Public Input No. 2427-NFPA 70-2023 [Global Input]

<u>File Name</u>	<u>Description</u>	<u>Approved</u>
PI_For_CMP_12_Voltage_Demarcation_.docx	Global PI for CMP 12 (Consistent Voltage Demarcation)

Informational Note Figure 620.62 Selective Coordination for overcurrent protective devices supplying more than one elevator.

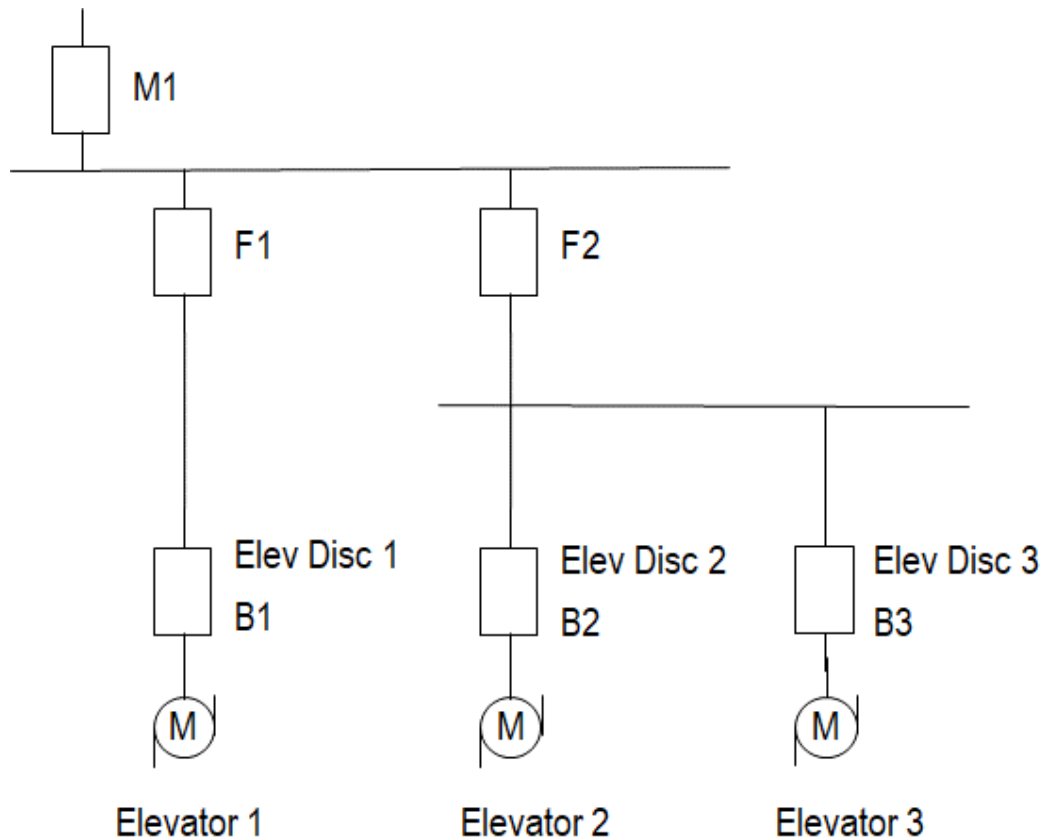
This public input clarifies that selective coordination needs to consider all overcurrent protective devices supplying elevators to assure an overcurrent condition will not result in loss of power to another elevator. An informational note and figure is added similar to that in NEC 700.32, 701.32 and 708.54.

Statement: This revision is necessary to provide clarification that if any component in the system is replaced, the selective coordination needs to be reevaluated. Exception and informational note were added to provide clarity to the requirement for how the devices selectively coordinate with each other.
